Town of Breckenridge
Planning Commission Agenda
Tuesday, July 21, 2009
Breckenridge Council Chambers
150 Ski Hill Road

Project Name/PC#:	Gardiner Residence Addition and Remodel	PC#2009031
Project Manager:	Julia Puester, AICP	
Date of Report:	July 13, 2009	For the July 21, 2009 Planning Commission Meeting
Applicant/Owner:	Randy Gardiner	
Agent:	Clifford Taylor Architects	
Proposed Use:	Single-Family Residence	
Address:	109 Sunrise Point Drive	
Legal Description:	Lot 14, Sunrise Point PUD	
Site Area:	12,806 sq. ft.	0.29 acres
Land Use District (2A/2R):	LUD 30.1 Residential Single Family PUD	
Existing Site Conditions:	This is a steep downhill lot of 30% with an existing home built in 1994 with primarily stucco and diagonal wood siding. There is a 30 utility easement at the rear of the lot as well as existing aspen, pine and other vegetation.	
Density (3A/3R):	unlimited	Proposed: 5,901 sq. ft.
Mass (4R):	unlimited	Proposed: 6,869 sq. ft.
F.A.R. Areas:		
Lower Level:	2,650 sq. ft.	(586 sq. ft. new)
Main Level:	2,430 sq. ft.	(824 sq. ft. new)

- Project Manager:** Michael Mosher, Planner III
- Date:** July 16, 2009 (For meeting of July 21, 2009)
- Subject:** Entrada at Breckenridge Mast

EAST ELEVATION
SCALE: 1/4" = 1'-0"

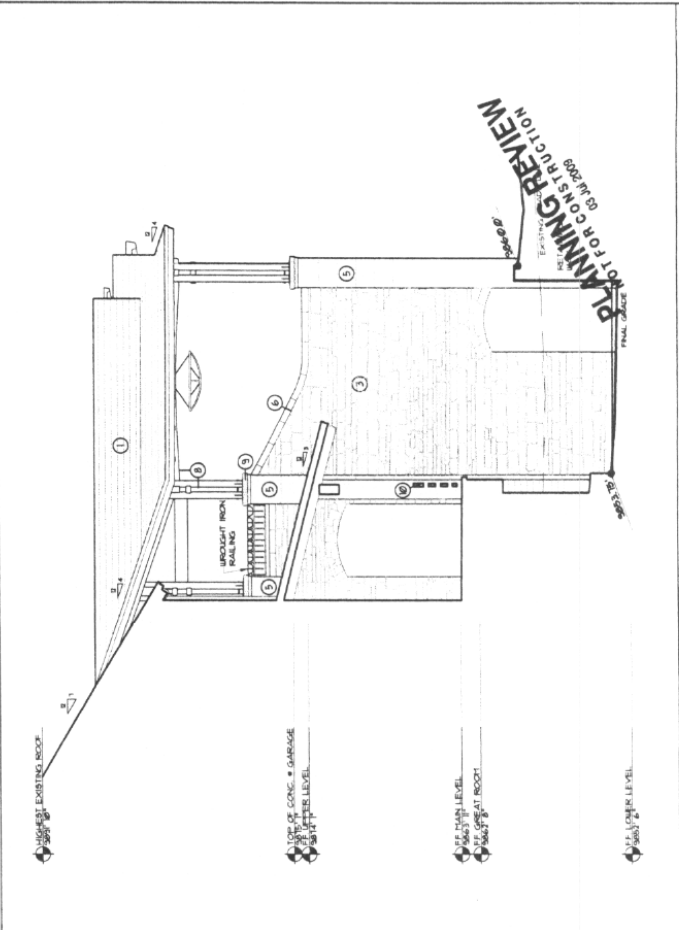
- Comments:** The stucco area proposed is located under the driveway which faces a steep grade and is not highly visible. It is 18% of the east elevation.
